MEMORANDUM

Topic: Case 23-31: All Nations Community Church Monument Signage, 18620 Kedzie Avenue

DATE OF MEETING: December 7, 2023

Figure B: Inset of design of proposed signage. Signage to be repeated twice to create Vpattern with monument signs at 60 degree angle.

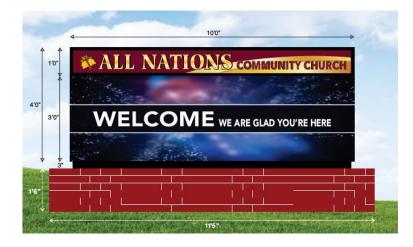
Each of the two proposed monument signs includes an LED backlit cabinet sign measuring 12 inches by 10 feet across the top of the sign serving as an identification sign for the church. The remainder of the sign area on each sign (36.5 inches by 10 feet) is an electronic bulletin board with changeable copy and LED display. The sign will be attached to an existing 1' 6" brick sign base with steel base plates with metal panels. The existing brick monument sign base is approximately 18 inches longer than the new sign, measuring 11 feet and 5 inches in length. The dimensions of all signage proposed meets the form standards found in the Village Code of Ordinances. No details on landscaping are currently provided by the applicant, and staff has provided recommendations for the provision of landscape plans which show details about any proposed landscaping to accompany the sign proposal and ensure a suitable transition between the ground and the proposed signage.

On-site analysis reveals that the signs are visible from multiple residential properties nearby, including two homes at 3200-3208 186th Street, two homes along Kedzie Avenue (18559 and 18655 Kedzie), and two homes along Mallard Drive (3201-3205 Mallard Drive). Electronic bulletin board signage may have impacts on these properties, where the signage is visible from the front of the residential structures where screening is not present. Staff recommends that restrictions be placed on brightness, the rate of change for messaging on the sign, and the ability to disable the sign when damage or signage errors are present.

Staff recommends numerous conditions which have been placed on other electronic bulletin board signs at civic and charitable institutions throughout the Village. These conditions are currently being recommended for inclusion as standardized form requirements for all electronic signs in most zoning districts. These conditions include:

- 1) All images displayed on signs shall remain static;
- 2) All messages on signs must have a minimum duration of 12 seconds without flashing, blinking, or movement;

- 3) Transitions between messages on the signs must be instantaneous;
- 4) No change in intensity or brightness, nor video displays of any type, shall be used to display any message

- 5) Single messages shall not divided between two screens,
- 6) No flashing or blinking shall be used for any message;
- 7) Exterior signs shall be illuminated only during business hours or between the hours of 6:00am to 11:00pm, whichever is later;

- 8) No off-premise commercial advertising shall be permitted at any time;
- 9) Brightness shall be limited to 0.00 foot candles at the residential lot lines;

- 10) In event of malfunction, the electronic bulletin board sign will be turned to dark screen until corrected; and
- 11) Compliance with standards set forth by the Illinois Department of Transportation,

In addition, staff recommends an additional condition for consideration by the Appearance Commission to protect nearby residential properties:

12) Brightness output for all displays, when used, shall be limited to 0.3 footcandles above ambient lighting conditions for all signage.
